BV1 (M-Note) SYSTEM BLOCK DIAGRAM

PROJECT : BV1
Quanta Computer Inc.

Revision History

BV1 / M-Note Schematic EC Tracking Record A (for DV --> SIV) Dec. 28, 2004

G_SENSOR Asm/NoAsm TABLE

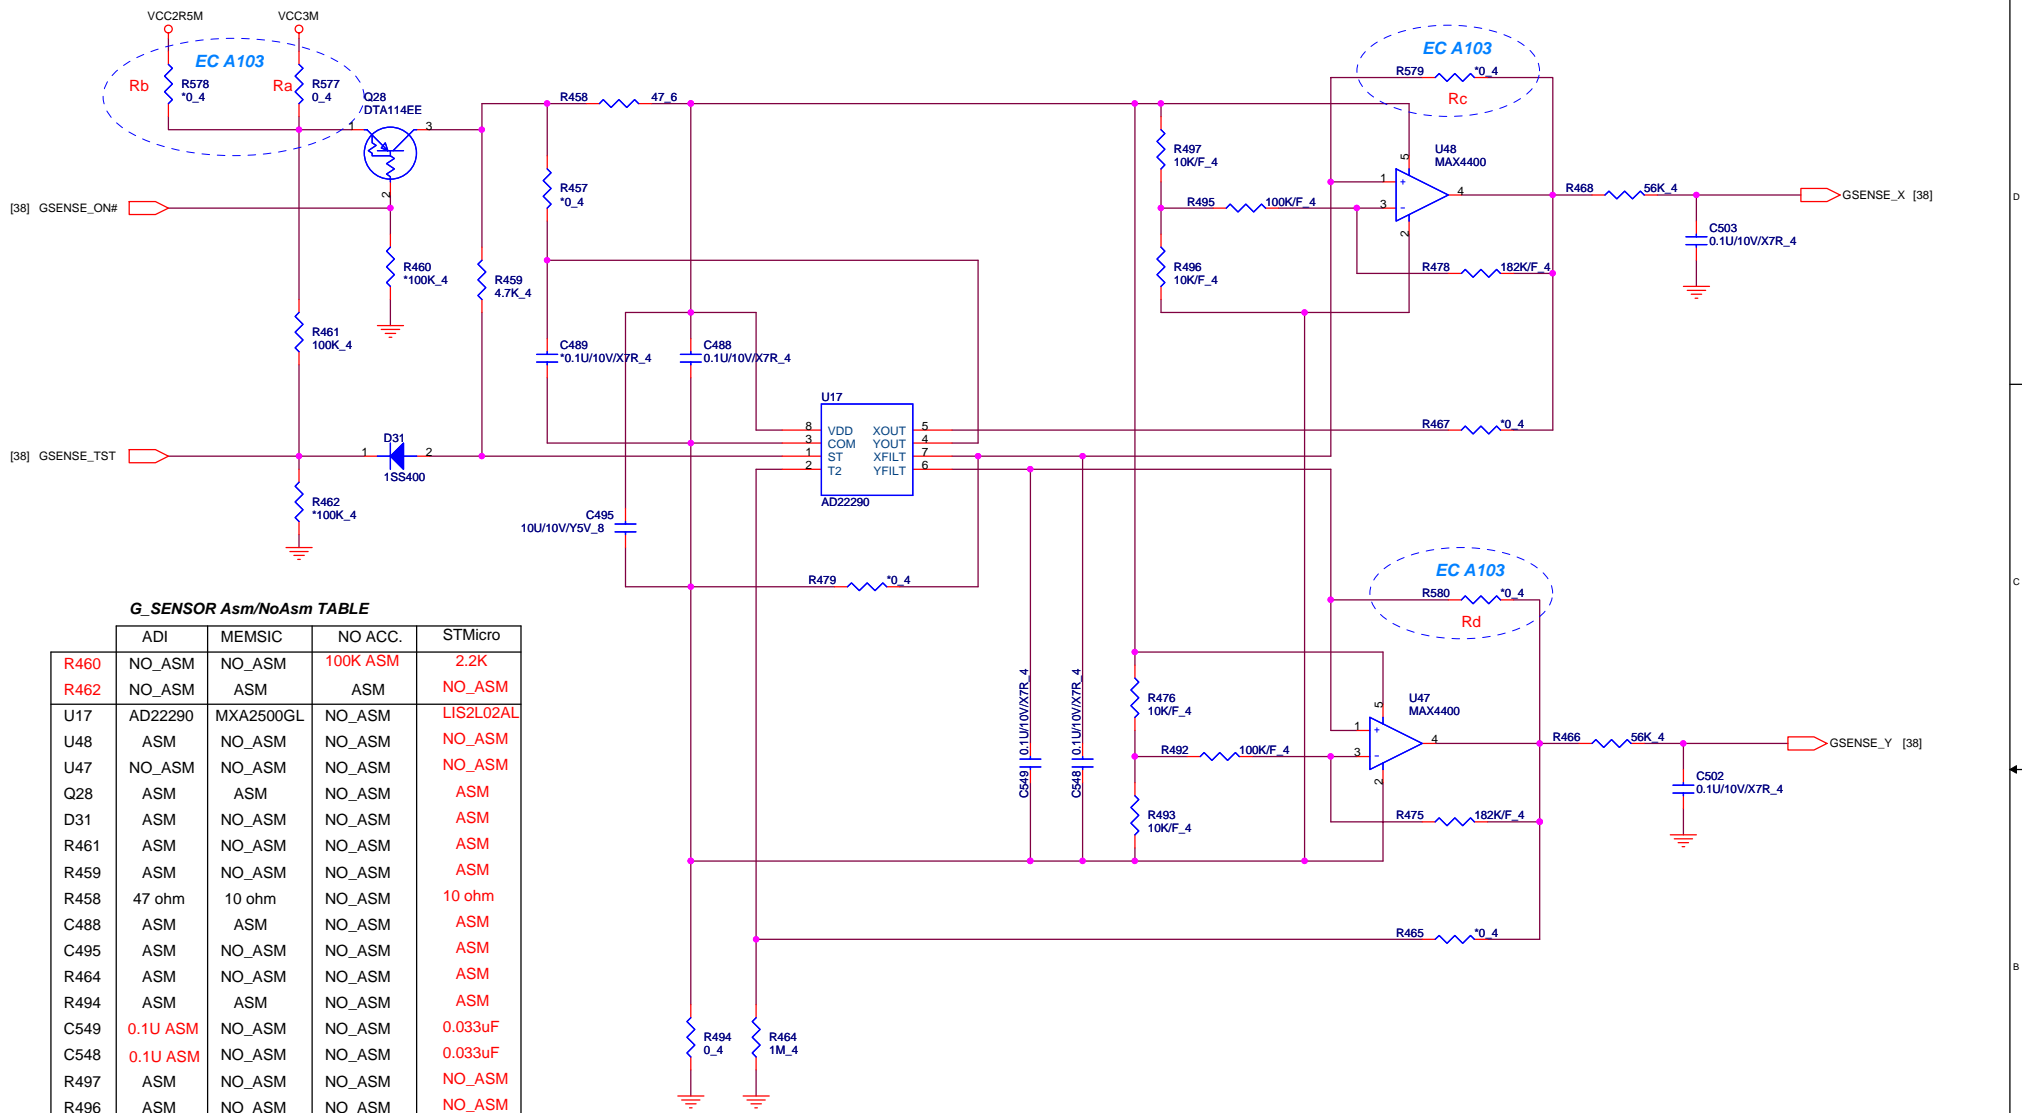
- EC A103/49/ Prepare to support new STMicro G-sensor. (SIV-IBM-43)
- EC A104/14/ Add bypass cap and delete some caps on LCD signal for EMI request.
- EC A105/39/ Add bypass cap on KB signal for EMI request.

- EC B39/11/ Change PCICLK 33MHz circuit for signal quality.
- EC B40/19/ Remove G2 short pad for IBM request.
- EC B41/49/ Correct G-sensor STMicro table as same as ADI.

Charger

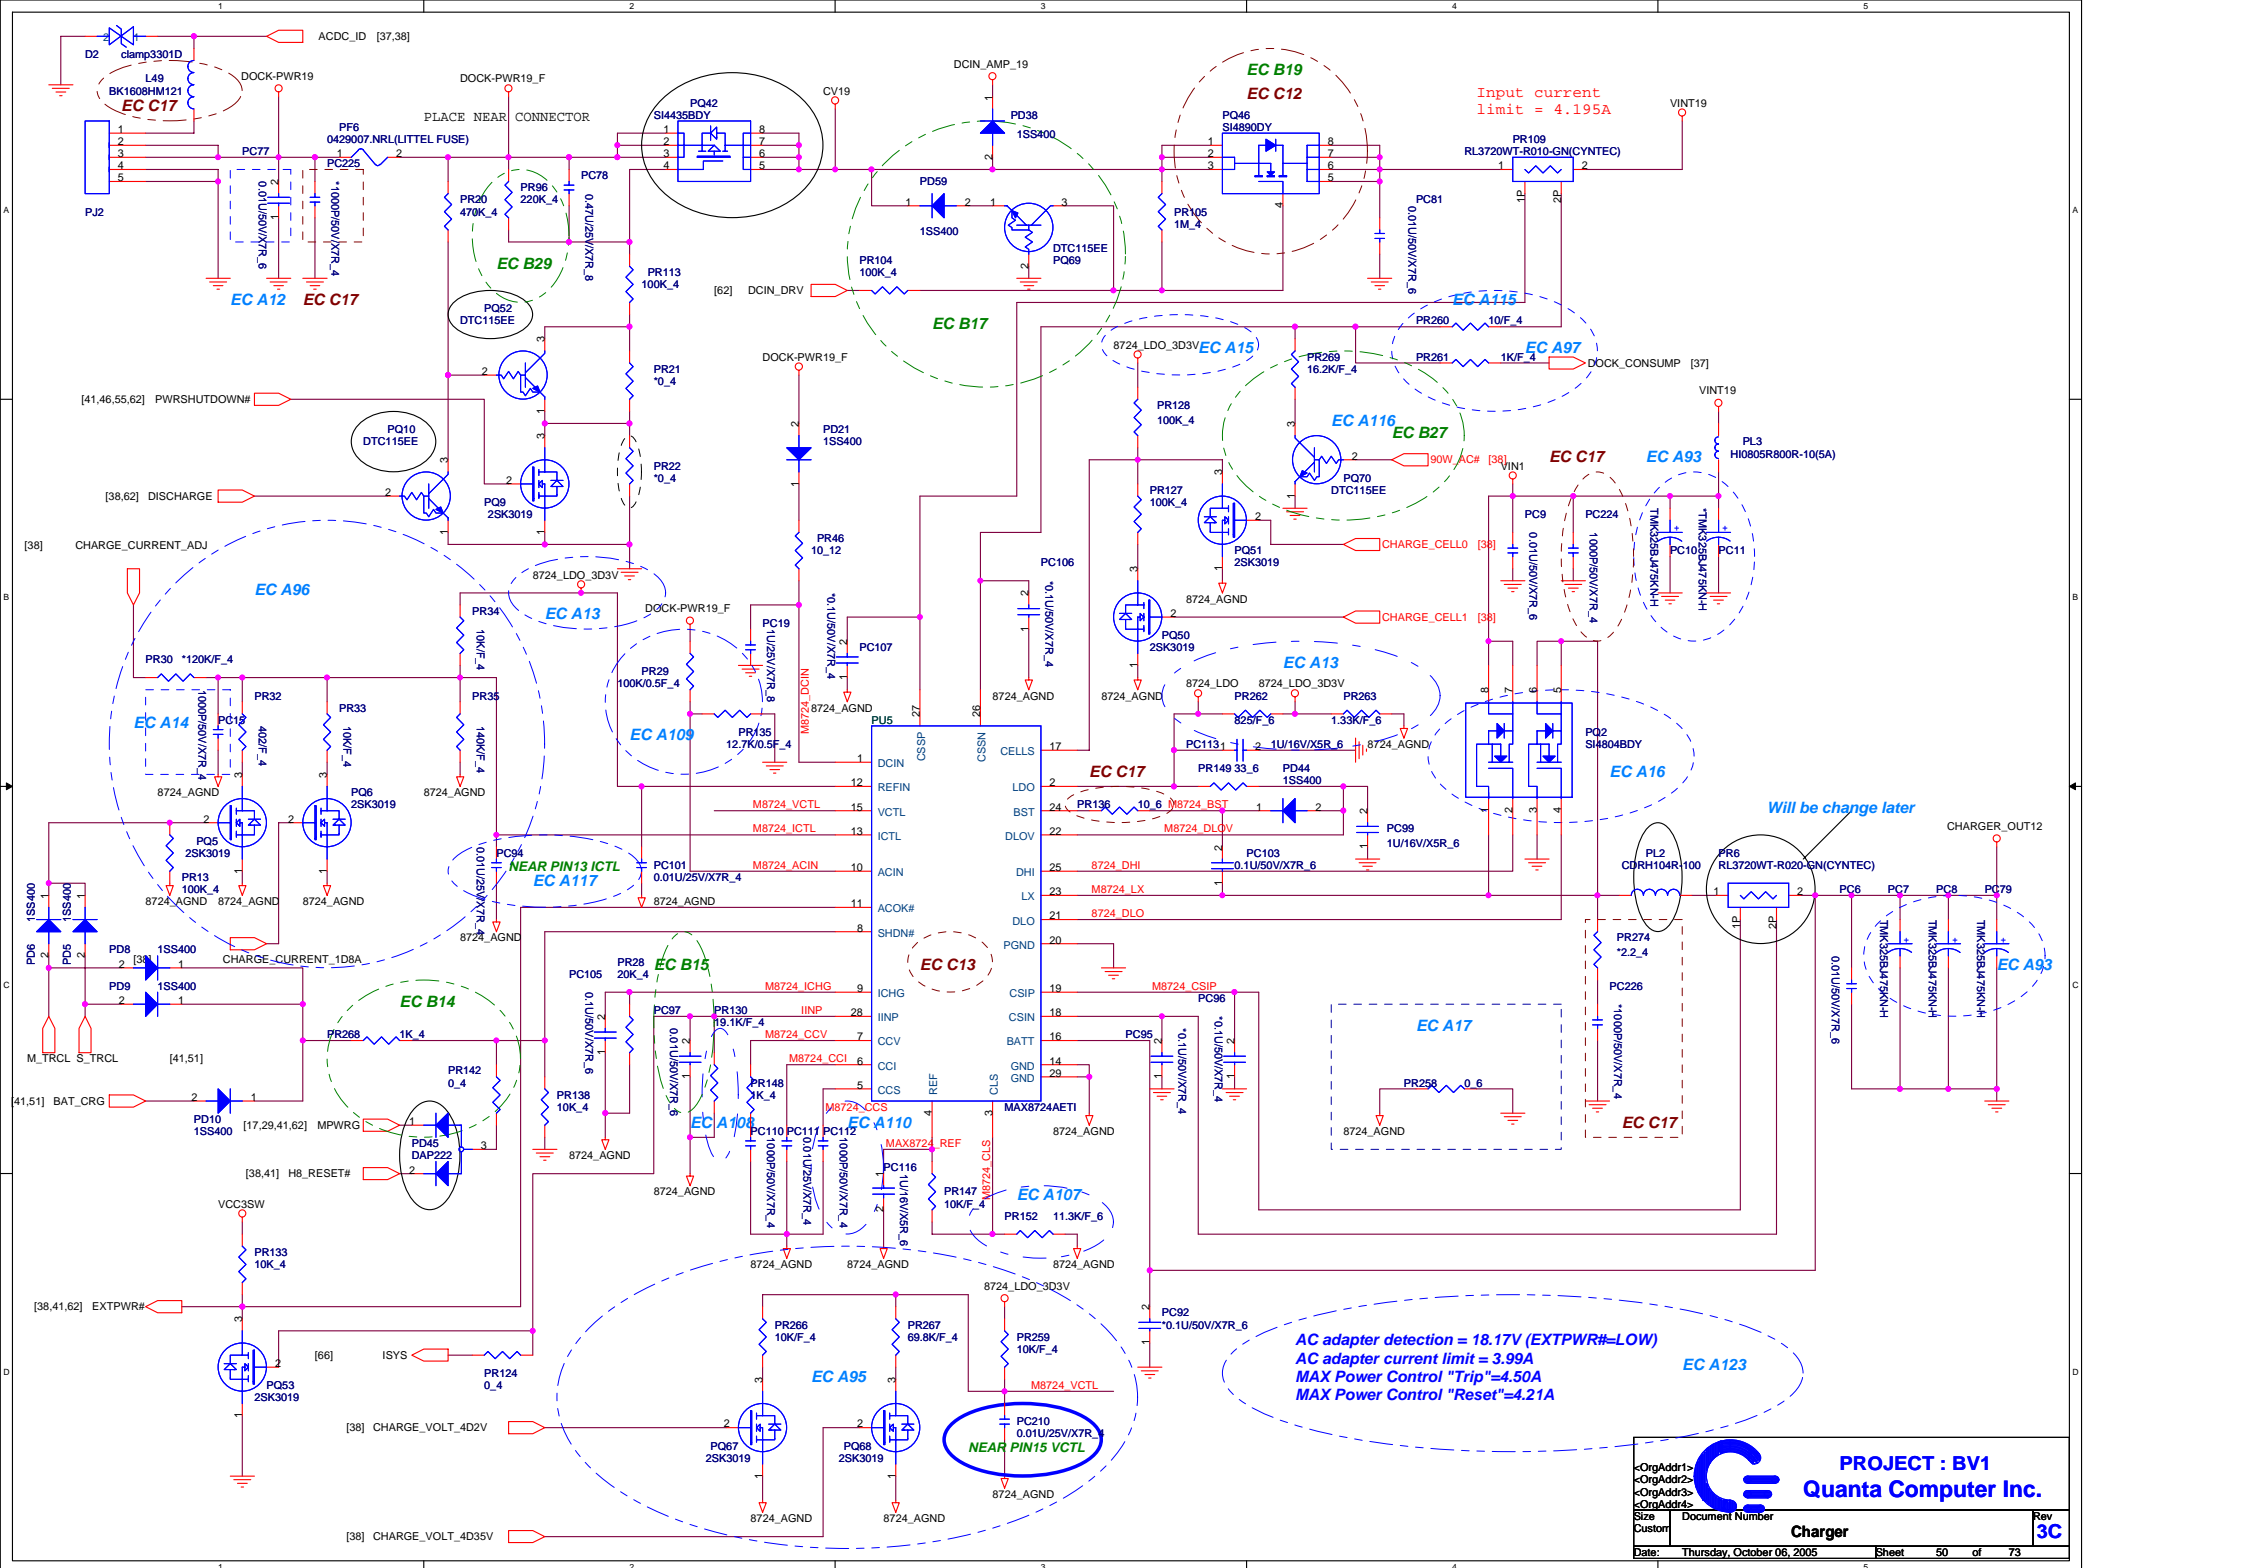
- EC A12/50/ Change PC77 from 0.1uF/50V/X7R to 0.01uF/50V/X7R.
- EC A13/50/ Make "8724_LDO_3D3V" by using pin_LDO and change PU5 pin12 REFIN power plane from VCC3M to 8724_LDO_3D3V.

- EC A14/50/ Change PC15 from NO ASM to ASM 1000P/50V/X7R.
- EC A15/50/ Change PU5 pin17 CELLS pull high power plane from VCC3M to 8724_LDO_3D3V. (SIV-IBM-48)

- EC A16/50/ Change PQ2 MOSFET from SI4804BDY to SI4978BDY.
- EC A17/50/ Add a 0 ohm resistor between the 8724_AGND and digital GND. Because PU5 MAX8724ETI ground was floating.

- EC A95/50/ For the accuracy of Charge Voltage (Cell voltage), pin_REFIN and "CHARGE_VOLT" signal should use same Power Net, and it was VCC3M.
- EC A96/50/ Modify pin_ICTL circuit.Pin_ICTL should also use 8724_LDO_3D3V.

- EC A107/50/ Change PR152 from 12.7k 1% 11.3k 1% ohm. (SIV-IBM-44)
- EC A108/50/ Change PR130 from 18.2k 1% 19.1k 1% ohm. (SIV-IBM-44)
- EC A109/50/ Change PR29 from 100k 1% 100k 0.5% ohm ; PR135 from 13k 1% 12.7k 0.5% ohm. (SIV-IBM-44)

- EC A110/50/ Change PC112 from 0.01U/25V/X7R to 1000p/50V/X7R.
- EC A111/51/ Change PQ49,PQ12 from SI2301BDS to SI2303BDS.
- EC A112/53/ Update footprint and change PD26,PD27 footprint to DSM.

- EC A113/64/ Delete PL22,PL23 for IBM power request.
- EC A114/41/ Change R400 from 6.8k to 100k ohm.
- EC A115/50/ Change PR260 from 10K 1% to 10 ohm 1%. (SIV-IBM-48)

- EC B13/30/ Change IEEE1394 common choke from DLW21SN261SQ2L (260ohm@100Mhz) to DLW21SN121SQ2L (120ohm@100Mhz). (SIT-IBM-18)
- EC B14/50/ Change MAX8724 pin_SHDN# circuit . (SIT-IBM-20)

- EC B15/50/ Change MAX8724 pin_IINP# circuit . (SIT-IBM-21)
- EC B16/14/ Change Q16 FET from SI3424DV to SI4890DY. (SIT-IBM-22)
- EC B17/50/ Change for AC Adapter polarity Test Fail. (SIT-IBM-26)

PROJECT : BV1
Quanta Computer Inc.
 CPU POWER
 Rev 3C
 Date: Thursday, October 06, 2005 Sheet 56 of 73

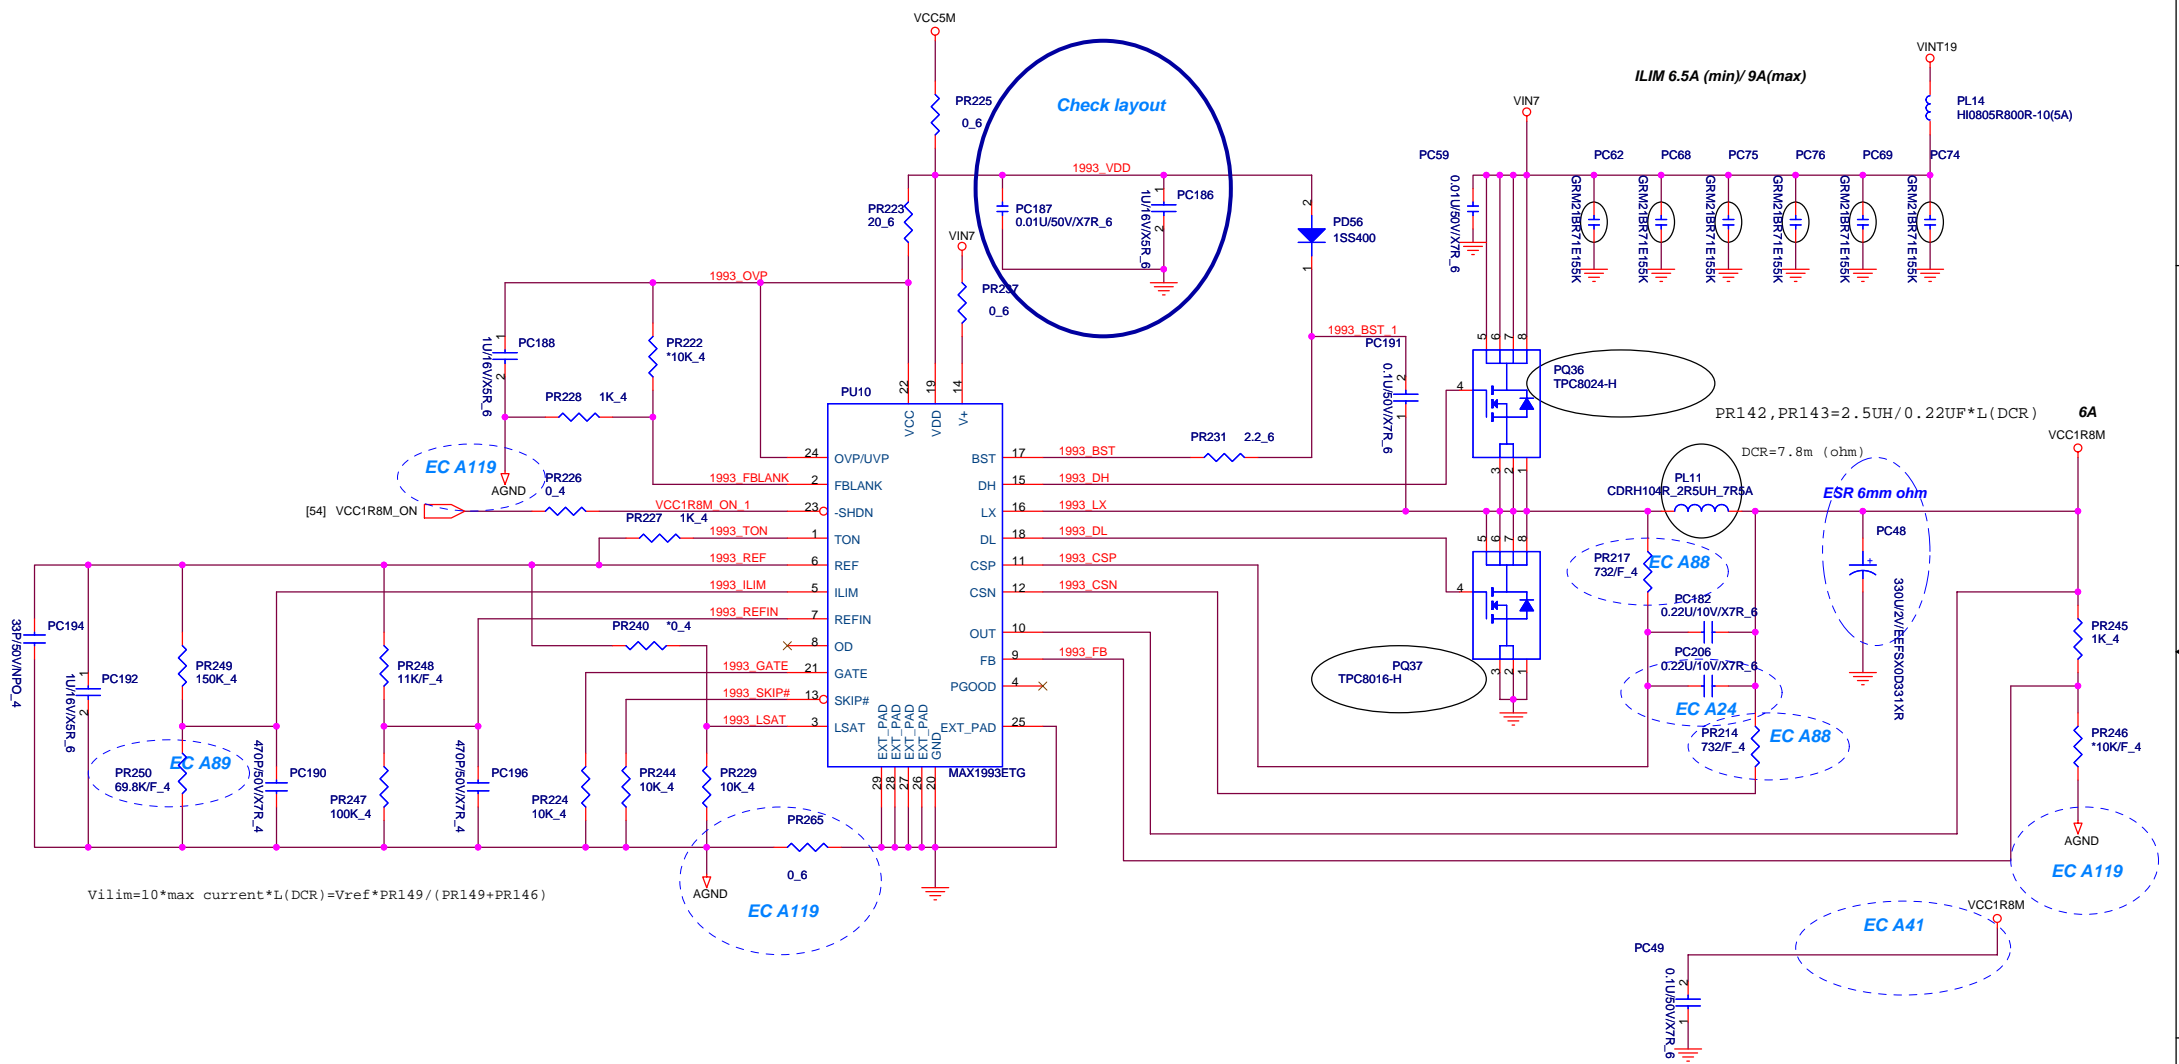
- EC A19/54/ Change PR85,PD32 from NO ASM to ASM.
- EC A20/55/ Change PL10 pin definition because it's different with layout footprint.
- EC A21/56/ Change PR70 from 324 ohm 1% to 383 ohm 1%.

- EC A22/56/ Change PR169 from 324 ohm 1% to 383 ohm 1%.
- EC A23/56/ Change PC146 from 330pF/50V/X7R to 680pF/50V/X7R.
- EC A24/58/ Add a 0.22uF/10V/X7R.

- EC B24/14/ Change F4 to 1206 footprint.
- EC B26/56/ Add NO ASM capacitors " GRM21BR71E155K" in VINT19 power rail to prevent any issue may happen like Voltage Dip on VINT19 or LCD Flicker or Acoustic Noise etc... (SIT-IBM-32)

- EC C01/56/ Change CLK_ENABLE# and VR_PWRGD pull-up power from VCC3M to VCC3B for leakage issue. Add PQ44. (SVT-IBM-01)
- EC C02/20/ Reserved R38 0ohm for SATA RSVD pin but not ASM. (SVT-IBM-08/15)

- EC C20/37/ Add ESD solution on PS/2 I/F
- EC C21/37/ Reserve 0ohm resistor on FRAME# & PCICLK on debug connector for security concern (SVT-IBM-18)
- EC C22/56/ Change PR193 & PR177 to ASM and value change to 10K
